PLANNING, ZONING, & BUILDING DEPARTMENT
PZ&B Staff Memorandum: Architectural Commission

SUBJECT: ARC-23-075 389 S LAKE DR.

MEETING: APRIL 24, 2024

Existing Conditions

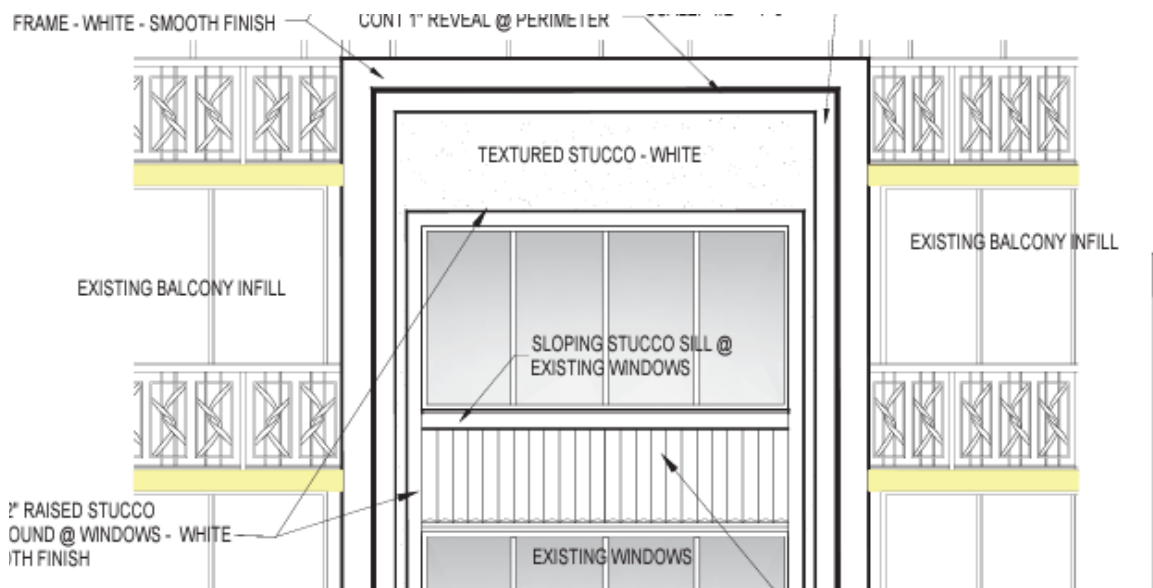
The replacement proposal alters the integrity of the building's architecture as the decorative breeze block railing was a character defining element of the Midcentury design and its permanent removal alters the architecture of the building. All 41-unit owners comprising of the Applicant unanimously approved of the proposed exterior façade changes to the Building.

The applicant received a building permit for concrete restoration and repairs in 2022, conditioned that the contractor would re-install the decorative lattice. Among the many reasons expressed in the applicant's letter of intent, ease of future maintenance is at the forefront. Life safety being another, as the master bedroom windows serve as a direct point of egress. Without doubt, the views of the waterway have improved with the removal of the sun shading device that formerly shielded the expansive fenestration. The project architect, acknowledging the significance of the element, proposes to enhance the window openings with new stucco surrounds and sills and install decorative railing at the window openings.
